UNITED STATES PATENT AND TRADEMARK OFFICE

APPLICATION NO.	FILING DATE	FIRST NAMED INVENTOR	ATTORNEY DOCKET NO.	CONFIRMATION NO.
10/019,650	01/03/2002	Haruko Toyoshima	0445-0316P	9924
2292	7590	03/24/2005		
BIRCH STEWART KOLASCH & BIRCH PO BOX 747 FALLS CHURCH, VA 22040-0747			EXAMINER KIDWELL, MICHELE M	
			ART UNIT	PAPER NUMBER
			3761	
DATE MAILED: 03/24/2005

Office Action Summary

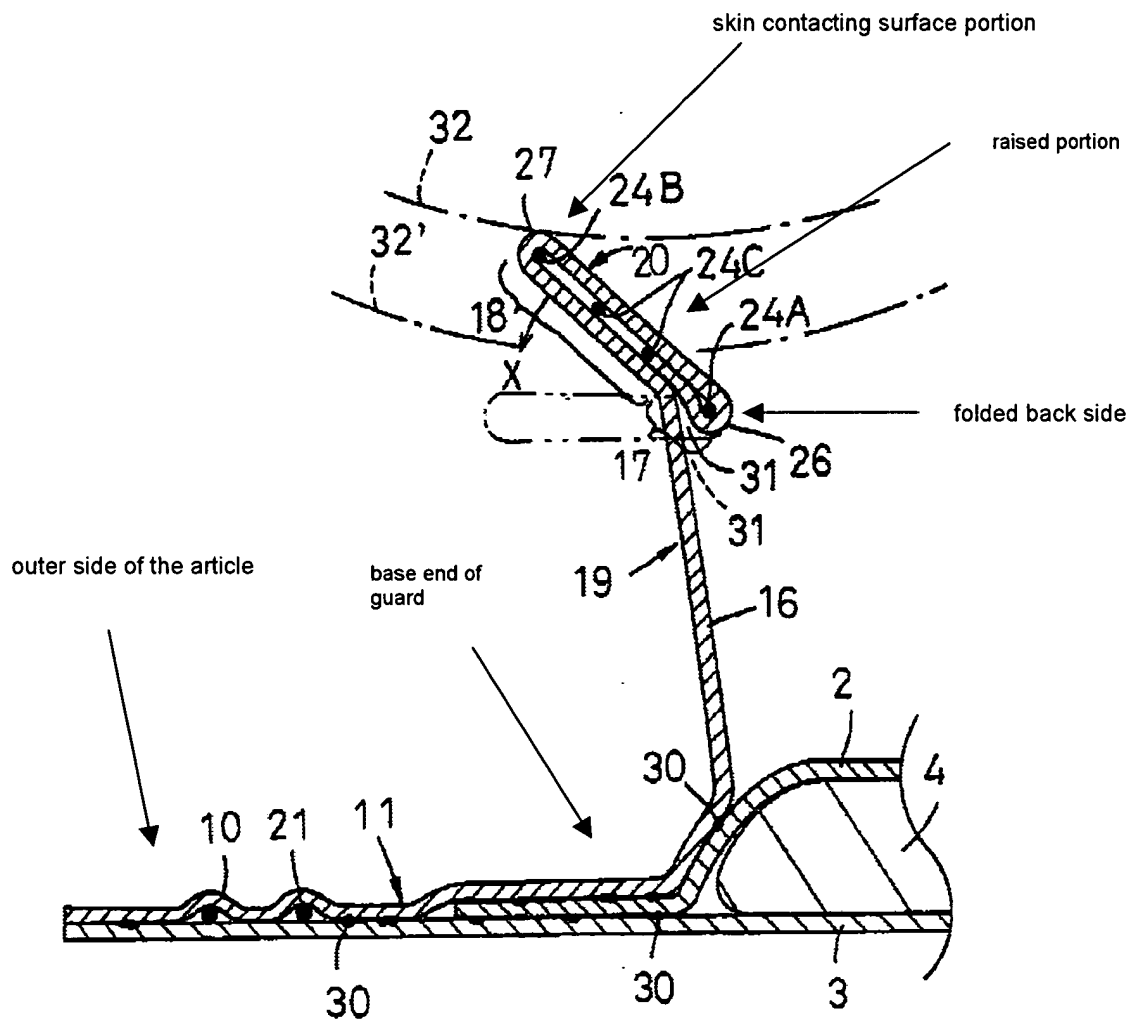
With respect to claim 5, see the rejection of claim 4. Any portion of the area designated 11 may be considered a leg portion having no leg gather. If the raised

portion is bisected, the lower half (which is considered the area above reference numeral 16 in figure 3) will have a larger stress than the upper half portion (the area beneath reference numeral 16 in figure 3) for the same reasons listed above.

In response to the applicant's argument that the claimed invention employs two sets of elastic members in contrast to Yoshioka, the examiner disagrees. The term "set" does not dictate the appearance of the elastic members. The term "set" is simply defined as more than one, not requiring the members to somehow be different in appearance or characteristic. As shown below in annotated figure 3, Yoshioka provides a "set" of elastic member on each of the claimed portions. Whether or not the set simultaneously contacts each portion is not a claimed limitation. The area above the raised portion arrow is considered the skin contacting surface portion having a set (24B and the first of 24C) of elastic members and the area below the raised portion arrow is

considered the raised portion having a set (the second of 24C and 24A) of elastic members.
